TS-180S Mods

Add 30-meter Transmit to Kenwood TS-180S Transceiver

DFC

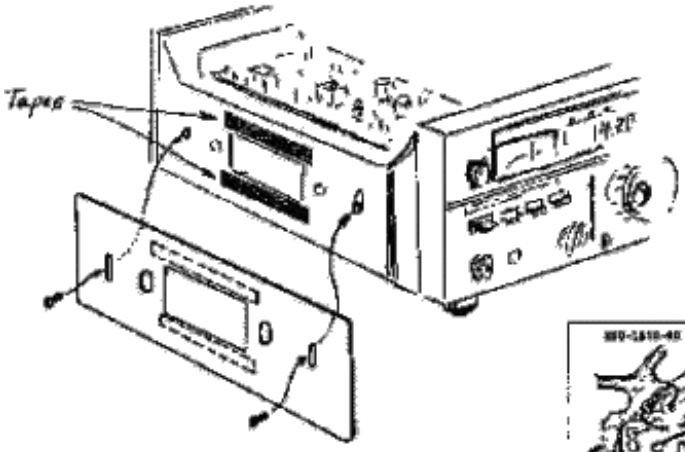
For complaints of either induced power supply hum, or intermittent frequency stability while using the DFC, perform the following changes to the VCO unit X50-1550-00:

Install a 330 Kohm resistor between Q11 G1 & the 8V line.
Connect from L7 at C12 to Q11 G1, at R35.
Replace L12 68uH with new part L40-6831-21.
Replace L13 150 µH with new part L40-1541-27.
Install magnetic shield as illustrated. Use the two existing screws, plus double faced tape to prevent vibration.

Note: On page 37 of the Service Manual, the VCO Board view shows reversed callouts for Q11 & Q15. D & S, and G1 & G2 are transposed.

DFC Instability

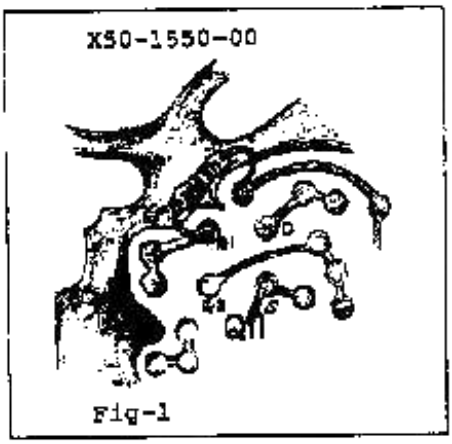
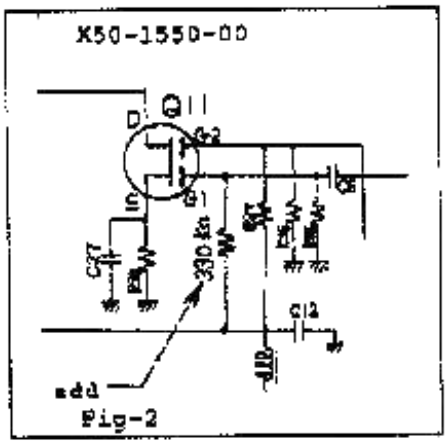
S-180S operators may report intermittent DFC instability, especially at 10 KHz even points. This may be characterized in some cases as PM'ing.

On the VCO unit X50-1550-00, install a 330 Kohm resistor between Q11 G1, and the 8V line. Connect from L7 at C12 to Q11 G1. at R35.

Note: On page 37 of the Service Manual, the Board view of the VCO unit contains reversed callouts for Q11 & Q15 FET's, D & S, and G1 & G2 are transposed.

DFC hum with PS-30

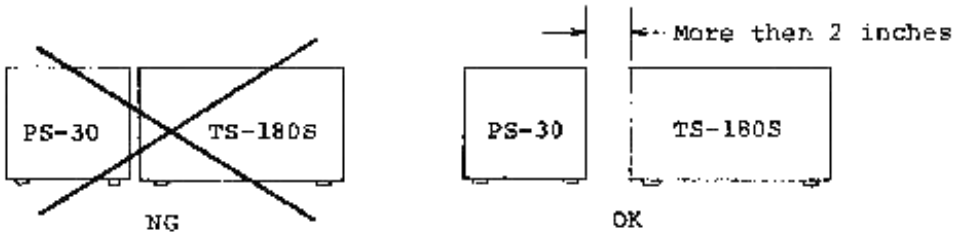
Some TS-180S users may report erratic DFC, and audio hum. You will find they have placed the PS-30 to the left of the transceiver. Hum is induced from the PS-30 into the DFC.

We are awaiting modification and production changes. Mean while, please be award of this problem. Temporarily moving the PS-30 to the right hand side of the transceiver will cure the problem. Spacing the two units with the SP-180, or just separating at least two inches will also cure the hum. When full information is available, we will follow up.

VFO Stability

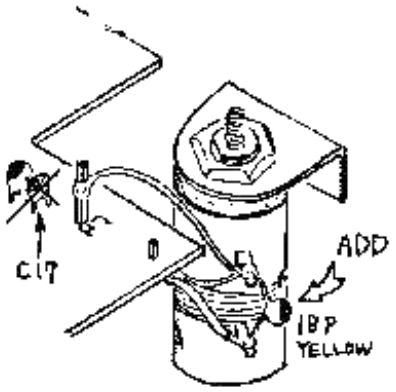
VFO drift characteristics may be improved by changing a capacitor value and location in the VFO.

4- Remove C17 from the PCB. This may be cut flush to the board.

5- Install the 18 pF yellow cap across the tank coil terminals. Position the cap near the coil.

New Part: 18 pF CC45RC1H180J
Old Part: 18 pF CC45PG1H180J

Analog Dial Calibration

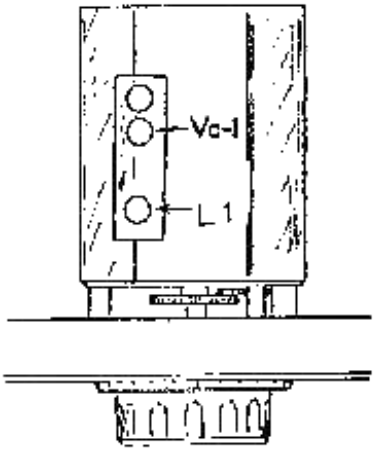
2- Note the digital error. If it is more than 2 kHz adjust the VFO trimmer cap VC1 (center under the sealing tape) to exactly 50.0 on the digital readout.

For instance, if the digital error is 14.454.0 (plus 4 kHz), multiply the error times 4 (16 kHz) and adjust the VFO trimmer cap to the desired frequency (14.450.0) LESS the error, or 14.434.0. Next, adjust the VFO inductor L1 (front under the sealing tape) back up to the desired frequency of 14.450.0.

Increase of RX Audio Output

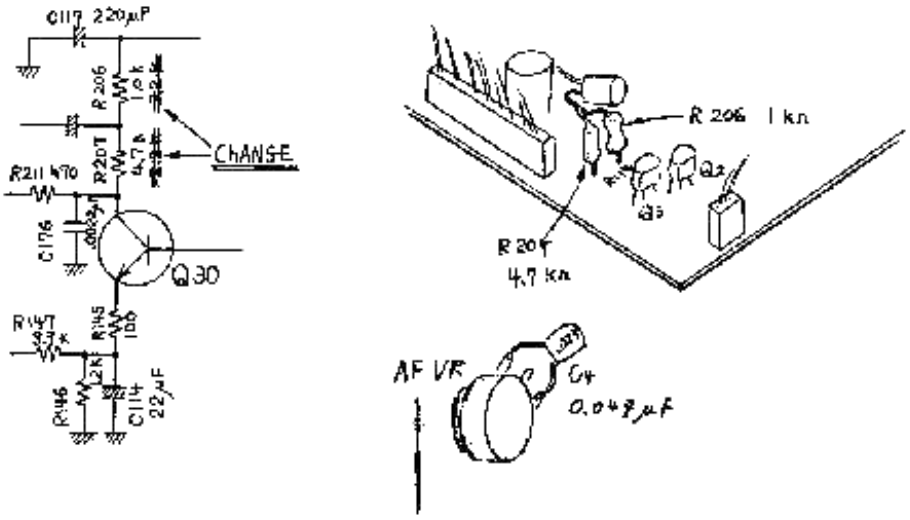
On the IF unit X48-1240-00 change components:

R206 2.2K change to 1 K ohn
R207 2.2K change to 4.7 K ohm

C4 .047uF change to .027uF mylar

IF output #2 Level Change for SM-220

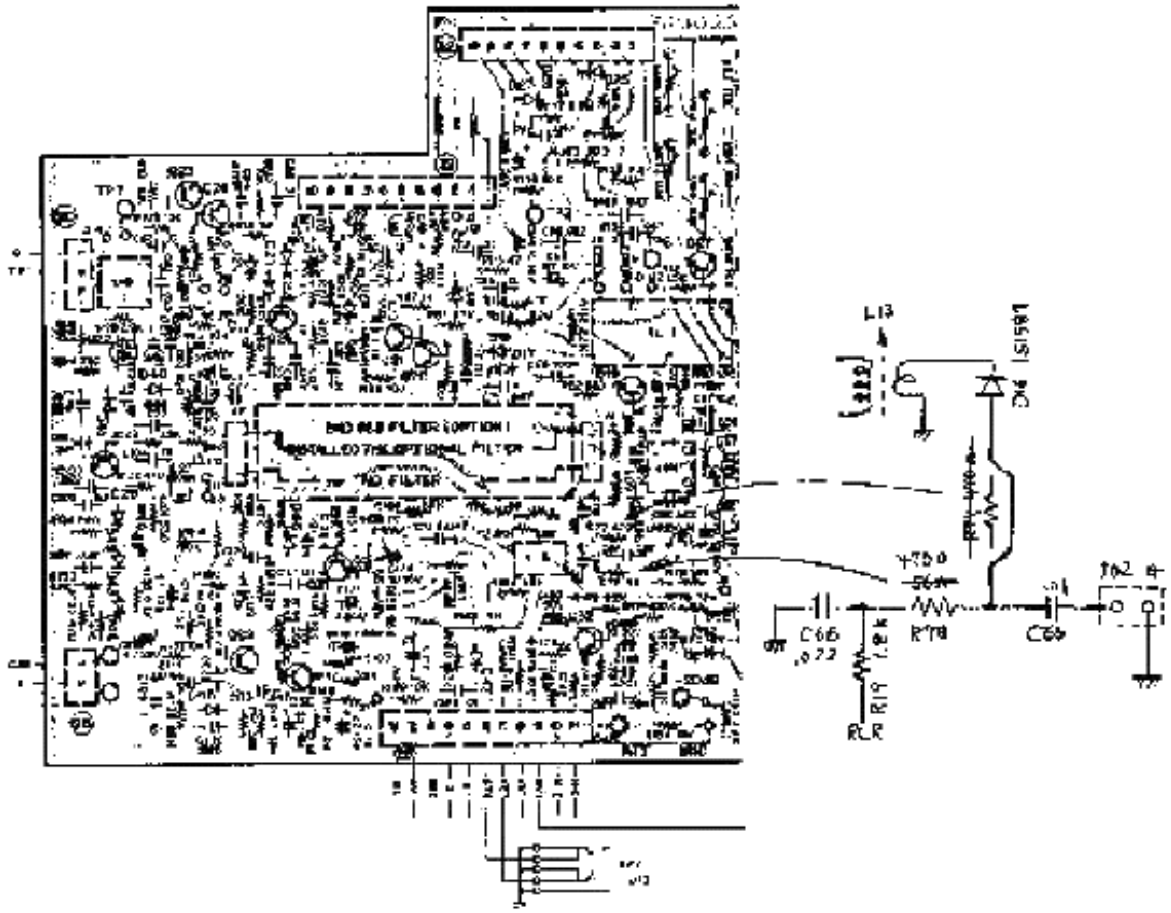
TS-180S owners who desire to operate an SM-220 for IF output display will require a wiring change to the IF unit X48-1240-00. No additional parts and no adjustments are required.

Remove R77, 470 ohm, and replace with wire jumper. Remove R78, 56 ohm, and replace with old R77. The 56 ohm resistor is not used.
